Technical Service Bulletin

97 MIL on, chafing found on transmission harness, DTC's: P157600, P157200, P218100, P260200, P260000
97 23 95 2070557/1 June 2, 2023.

Model(s)	Year	VIN Range	Vehicle-Specific Equipment
A6 allroad, A6, and S6	2023	043477 – 046976	Not Applicable

Figure 3: Optimized routing for generation 06S.

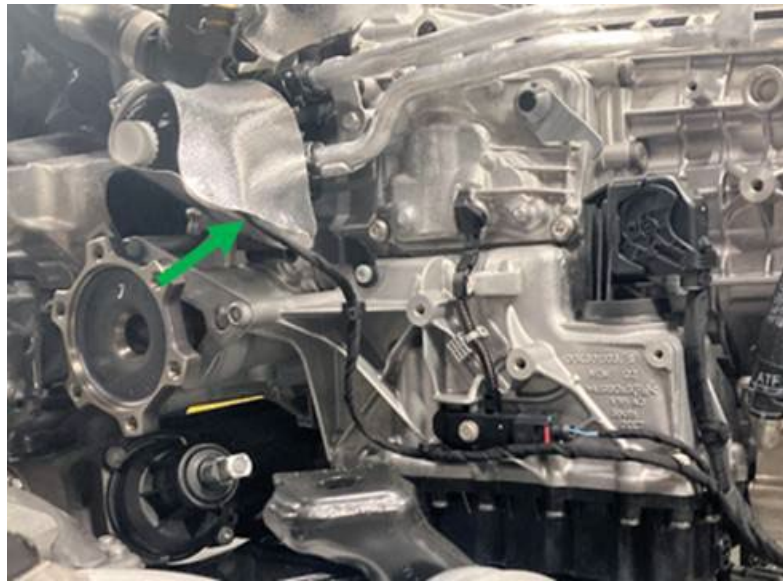
Wiring harness routing for generation 06S:

The generation 06S wiring harness **must be** routed through the circulation pump heat shield (the two buttons determine the position, green arrow, Figure 3).

Warning: If this is not performed, the wiring harness will make contact with the drive shaft again.

Figure 4: Optimized routing for generation 07S.

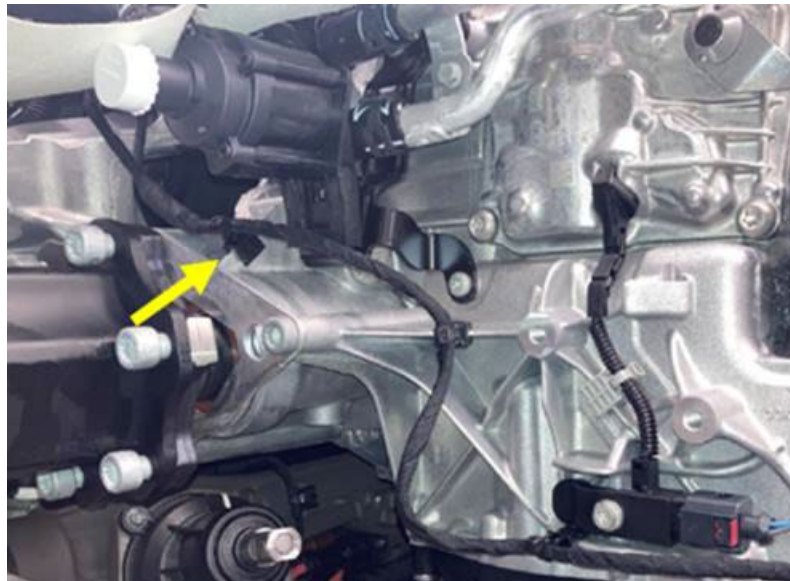
Wiring harness routing for generation 07S:

Generation 07S has a different shape and an additional retaining element (see yellow arrow in Figure 4). Generation 07S **must not be** routed through the circulation pump heat shield.
